Subject: AP1000 Response to Request for Additional Information (SRP 6)

Response to Request for Additional Information on SRP Section 6

RAI Response Number: RAI-SRP3.7.1-SEB1-16
Revision: 2

Figure RAI-SRP3.7.1-SEB1-16-1: AP1000 Auxiliary & Shield Building Main Control Room - Hard Rock High Frequency Safe Shutdown Earthquake Floor Response Spectra Horizontal Direction, At Elevation 116.5'

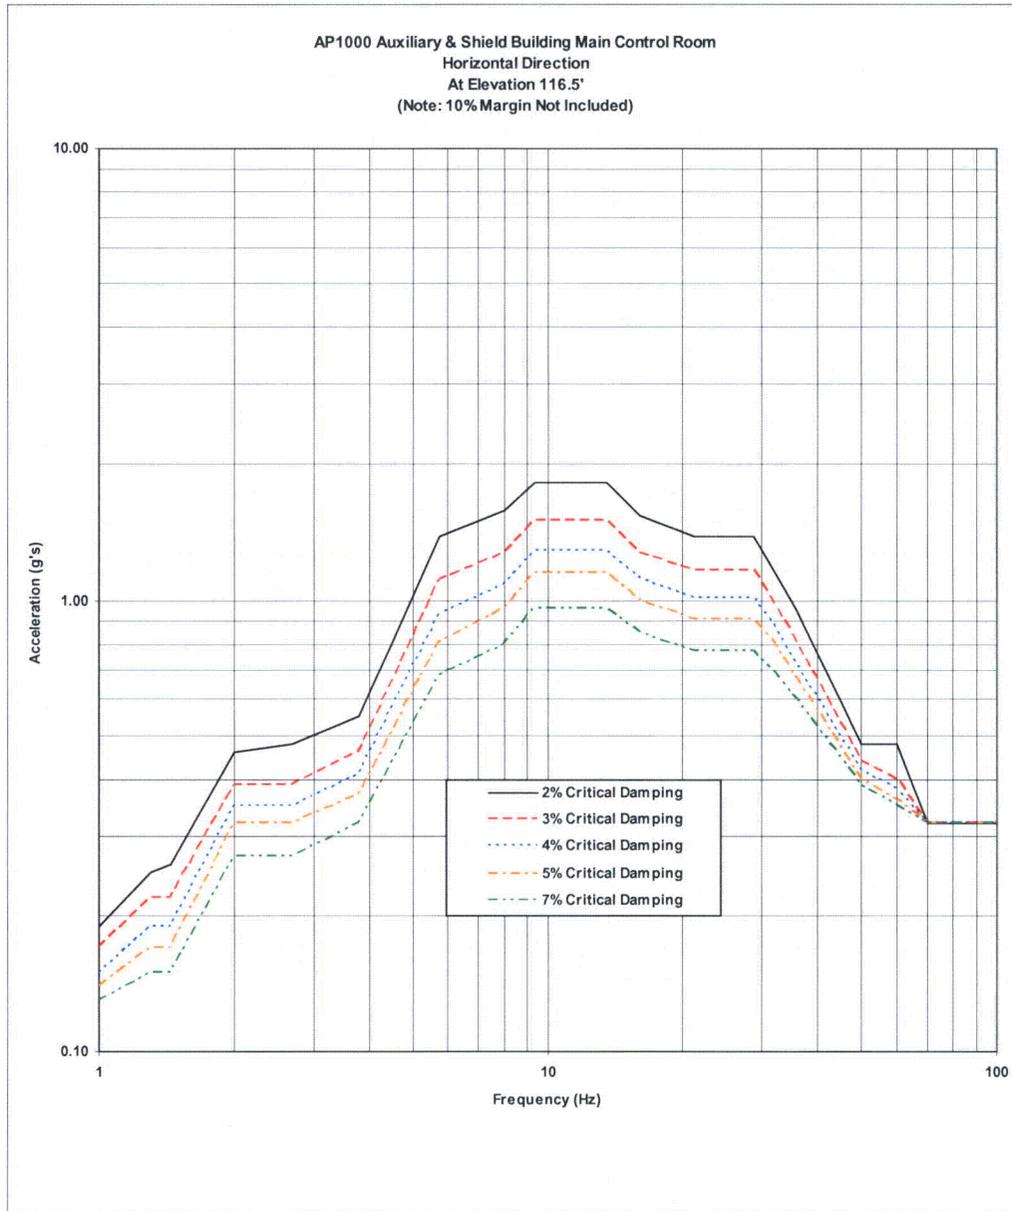
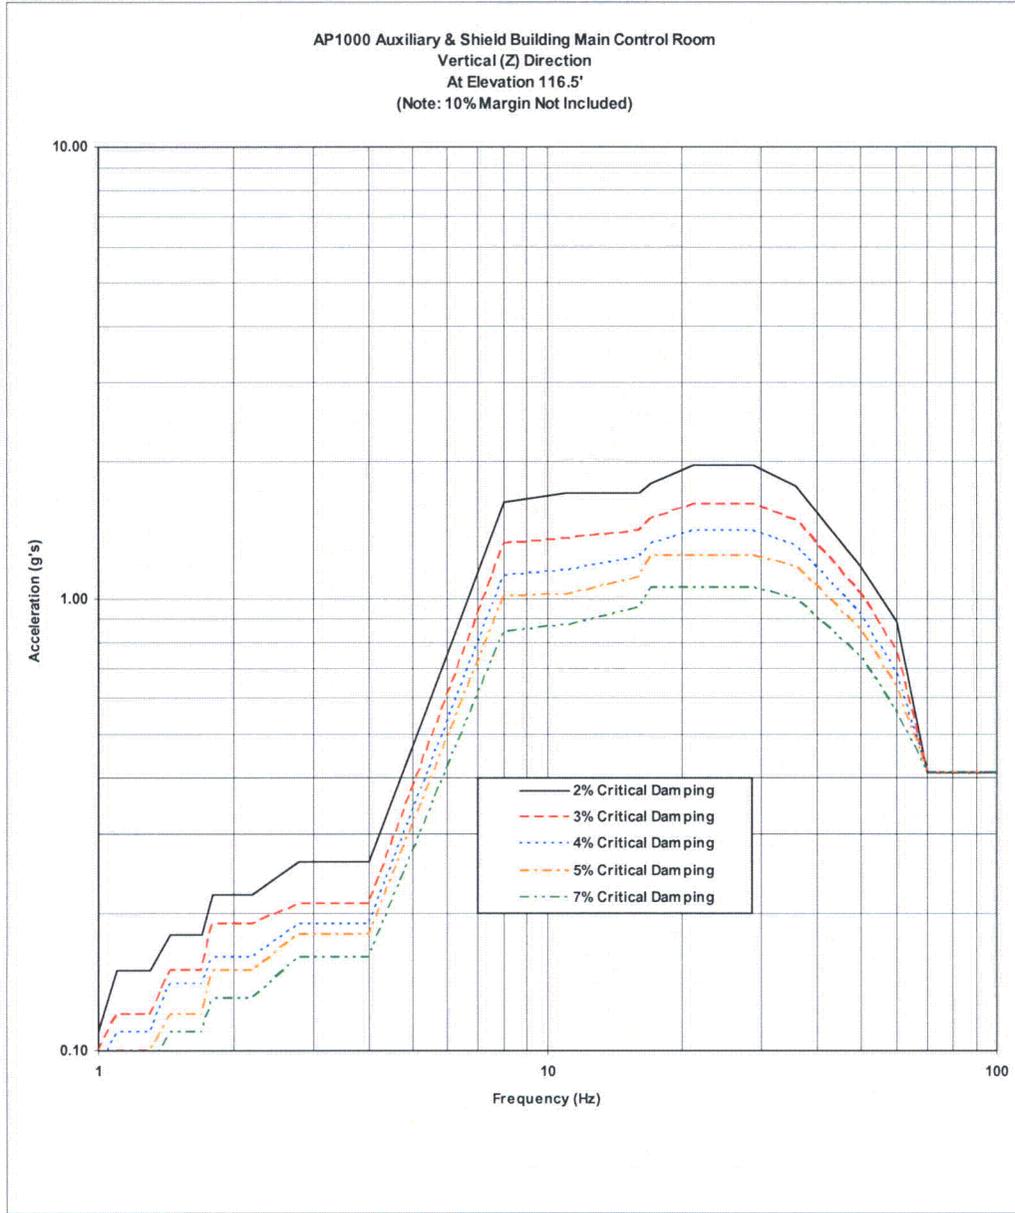
02/25/09 UPDATE: Response submitted 02/06/2009. The responses to (a), (b), (c), and (d) are unacceptable. For (a), only the structural loads are addressed. The more important

consideration is the effect on the HRHF in-structure response spectra needed for analysis of systems and components potentially susceptible to high frequency excitation. For (b), W needs to define a technical basis for demonstrating similarity. Otherwise, it is subject to interpretation by each COL applicant. For (c), the impact of complying with RG 1.61 Rev.1 for electrical cabinets is negligible, since seismic qualification analyses have not been performed yet. If seismic qualification is by test, the specified damping for analysis has no importance. For (d), W needs to justify using 5% damping for piping analyses using HRHF in-structure response spectra. This is a violation of the Rev. 15 FSER. Complying with RG 1.61 Rev.1 damping for piping analyses would require minimal re-work, if any. The design-basis piping seismic analyses for most, if not all, systems that will utilize uniform support motion RSA methodology and 5% damping, have not been performed yet.

To address the potential that the seismic response for the HRHF SSE ISRS may have been underestimated, additional seismic test margin will be introduced into the HRHF seismic screening evaluation of safety-related equipment vulnerable to HRHF excitation. U.S. NRC R.G. 1.61, Rev. 0 identifies a critical damping value of 4% for ½ SSE analysis of reinforced concrete structures. The margin between 4% critical damping and the 7% critical damping used for the building structural analysis is approximately 30%. This margin will be realized in seismic testing by using the 3% damping HRHF SSE ISRS as though it were a 5% damping HRHF SSE ISRS. Figures RAI-SRP3.7.1-SEB1-16-1 and RAI-SRP3.7.1-SEB1-16-2 provide a comparison of the 3% and 5% HRHF SSE ISRS for the Main Control Room (horizontal and vertical direction) which shows a margin of approximately 30% for frequencies below the ZPA.
